Addendum D3

re: **City of Berne**
New Municipal Maintenance Building
335003.00

date: **February 23, 2024**

ADDENDUM NO. 3

UTILITY PLAN

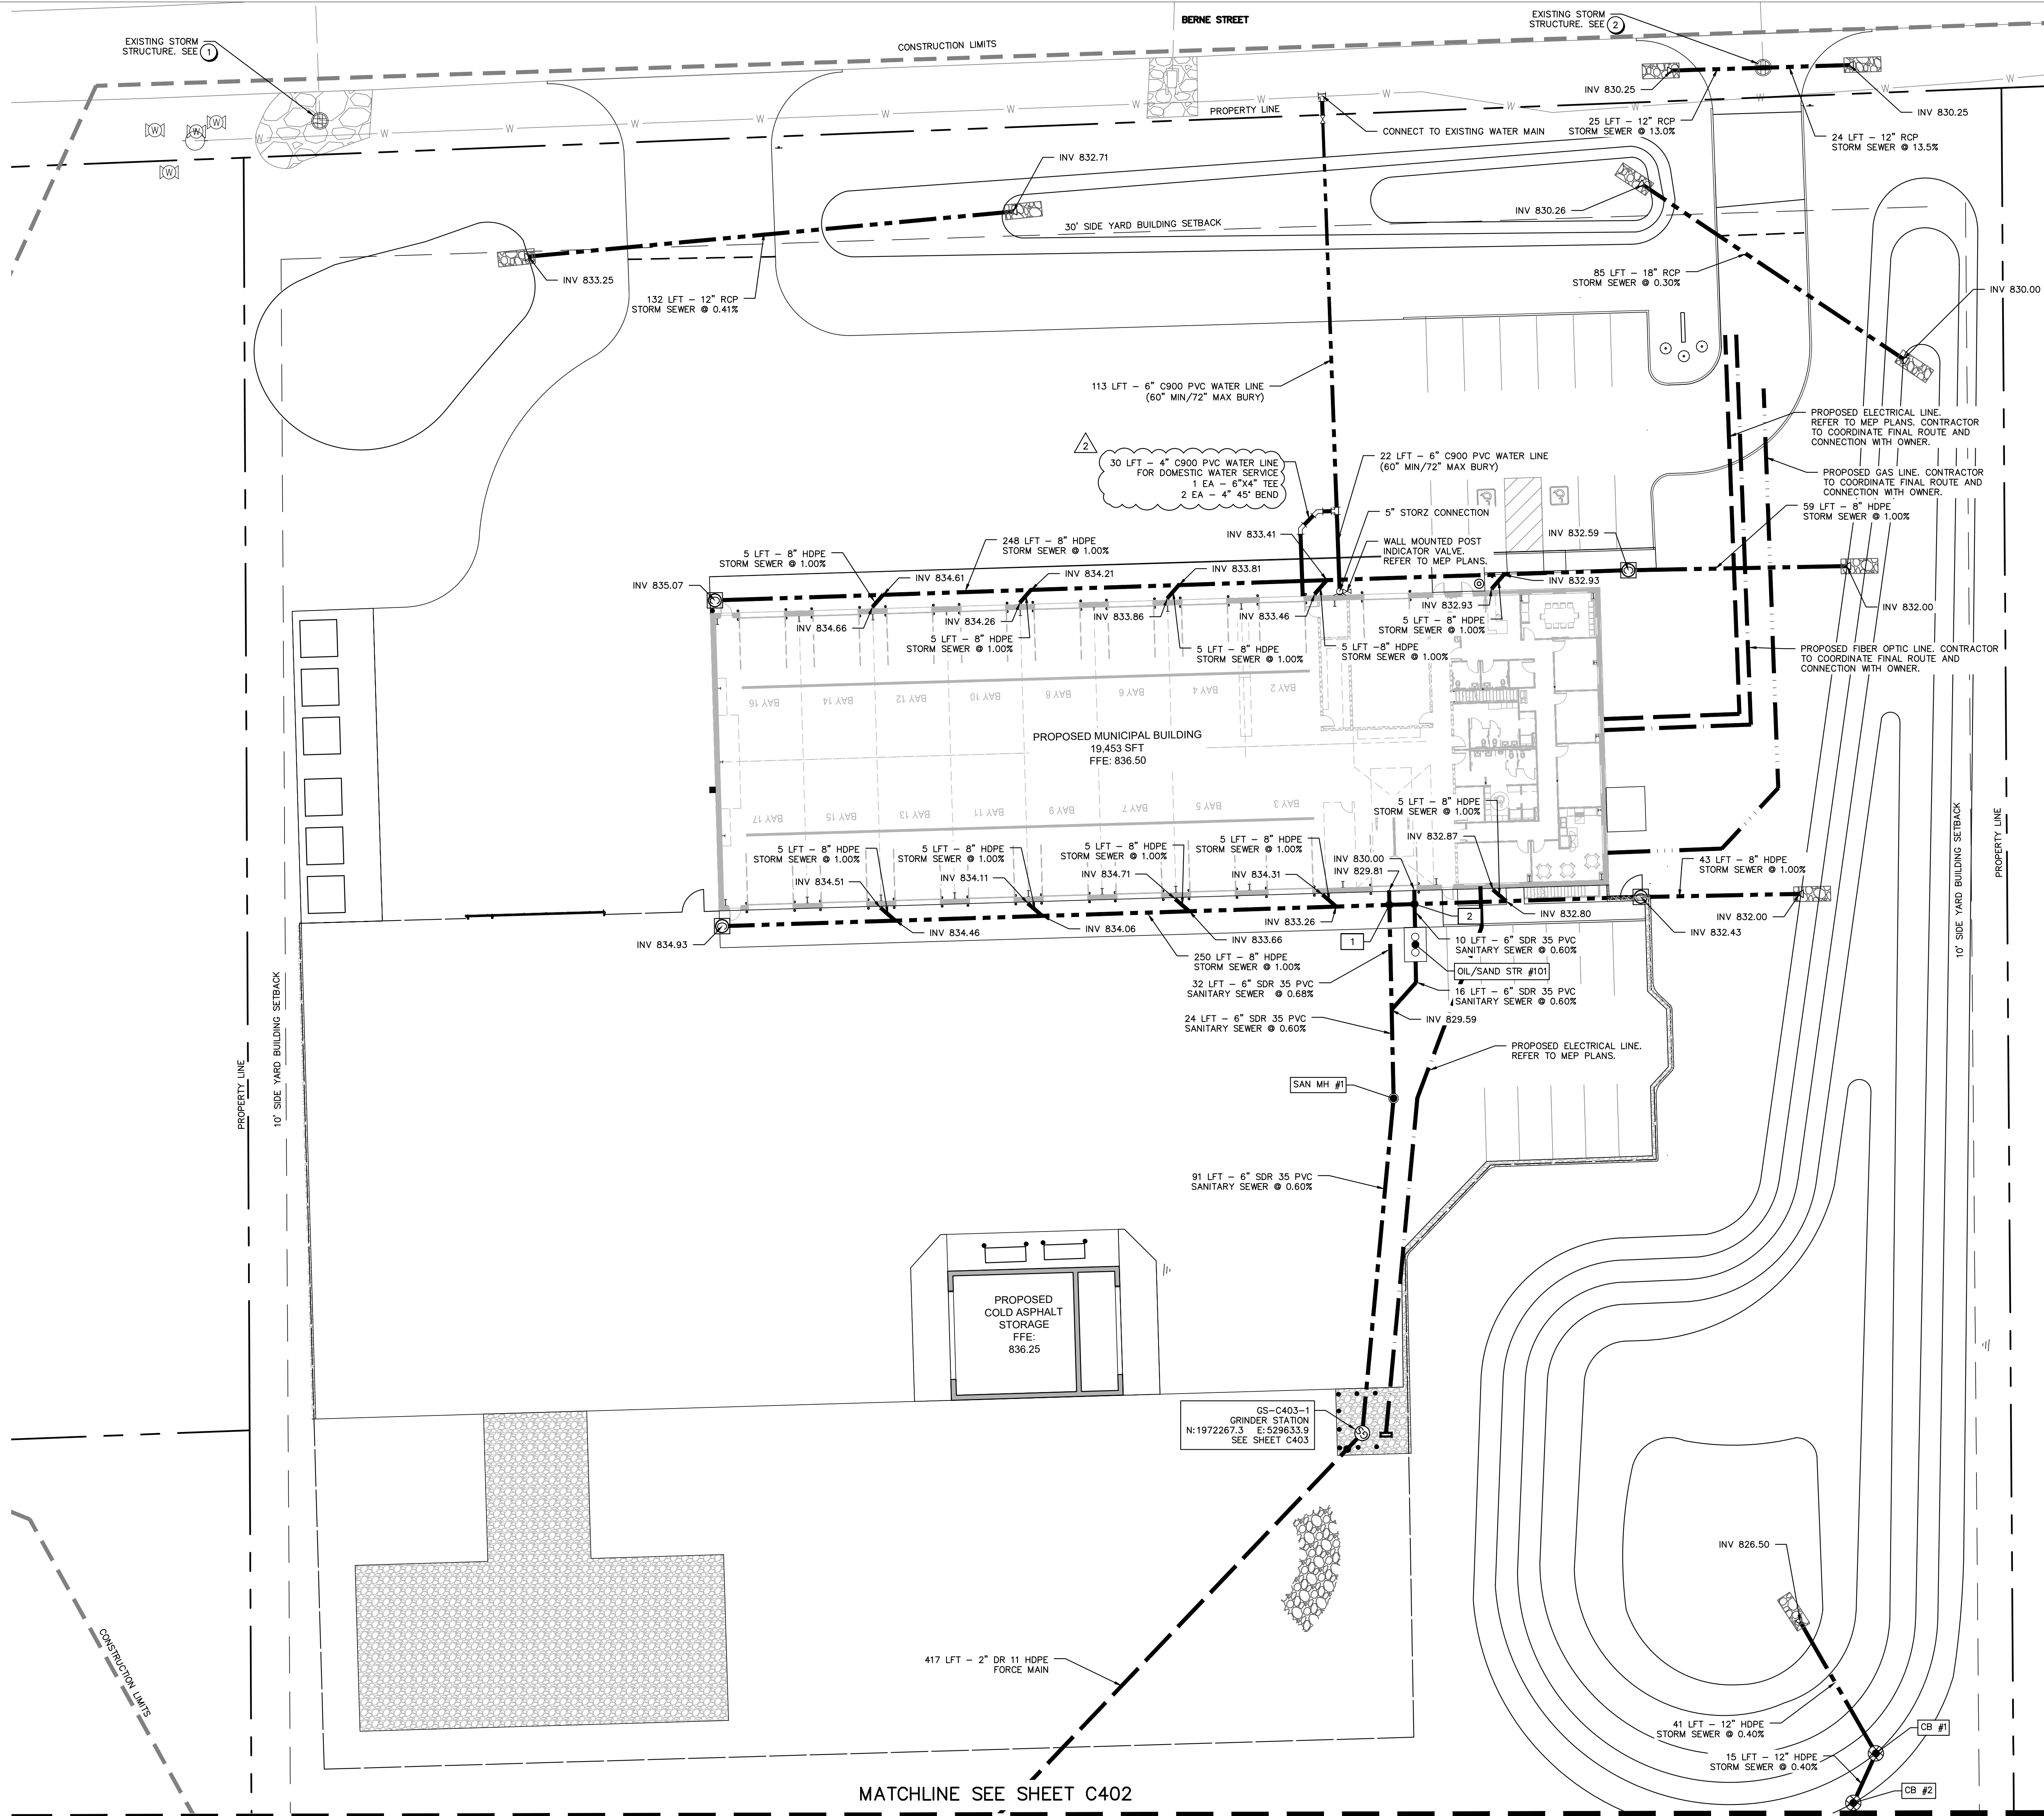
C3.01	DRAWING C401 <i>(Drawing Reissued)</i>	<u>REVISE:</u> REVISE Legend symbol for Proposed Catch Basin to match plans.
C3.02	DRAWING C501 <i>(Drawing Reissued)</i>	<u>ADD:</u> ADD Temporary erosion control inlet protection symbol on existing inlets along Berne Street.
